Re: Amendment to MRP to Construct Waterway and Re-Paving of Parking Area Adjacent to Office Building, Task ID# 4780, Sufco Mine, Canyon Fuel Company, LLC, Permit Number C/041/0002

Title: Amendment to Construct Waterway and Repaving of Office Parking Lot, Task ID#4780

**SUFCO PARKING LOT
 GRADING PLAN**

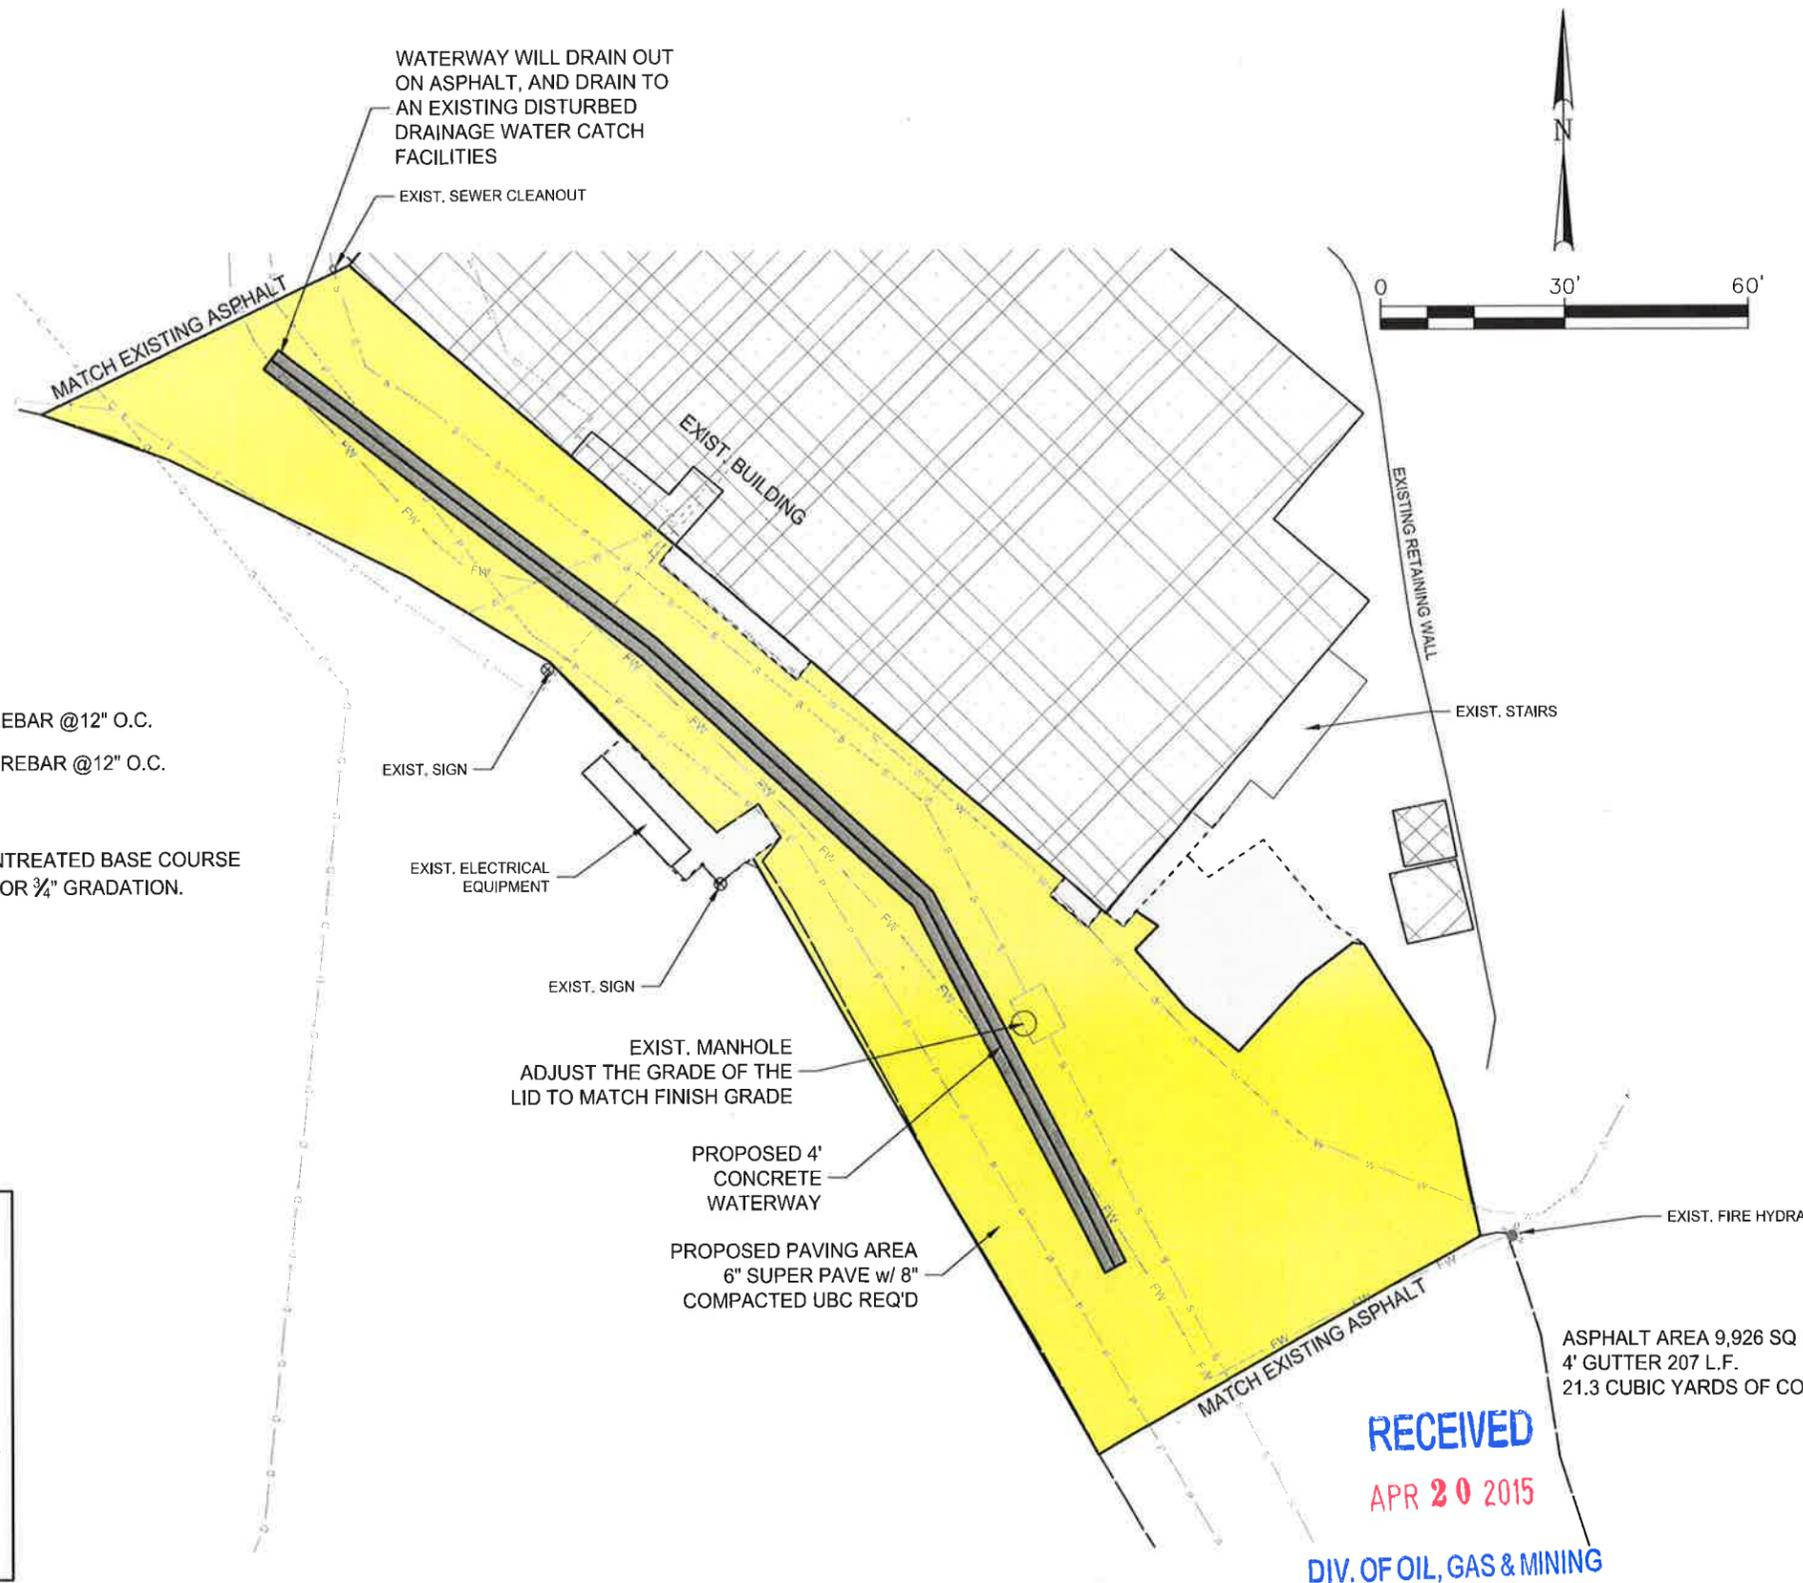
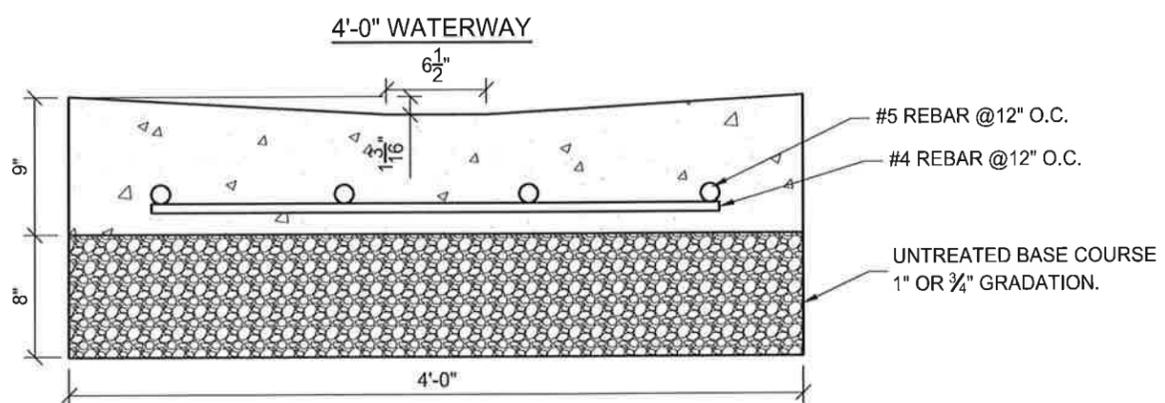
Sufco Parking Lot (Constructed 1950's) - A plan has been provided in Appendix 5-12 for the replacement of the asphalt in parking area adjacent to the mine office building. After removal and prior to replacing the asphalt, the area will be re-graded to slope to the center of the parking area where an installed concrete waterway will assist in directing precipitation/water into structures in the permitted drainage plan to the sediment pond.

If necessary a grade ring will be added to the existing manhole to bring the manhole cover up to the grade of the replaced asphalt.

Due to the limited knowledge of the material beneath the existing asphalt there is uncertainty to whether existing material or acquired untreated base course will be used. Existing native material will be used for the construction base when it's characteristics meet compaction standards, however when required untreated base course (0-8") will be used. Excess native material generated during the regrading of the parking lot area depending on it quality will be hauled to the waste rock site and either mixed with the waste or placed on the subsoil pile. The area to be re-paved ties into existing features on each end which will require the grade to be similar to the grade prior to the repaving and installation of the concrete waterway. The reclamation cut/fill calculations for this area should remain unchanged.
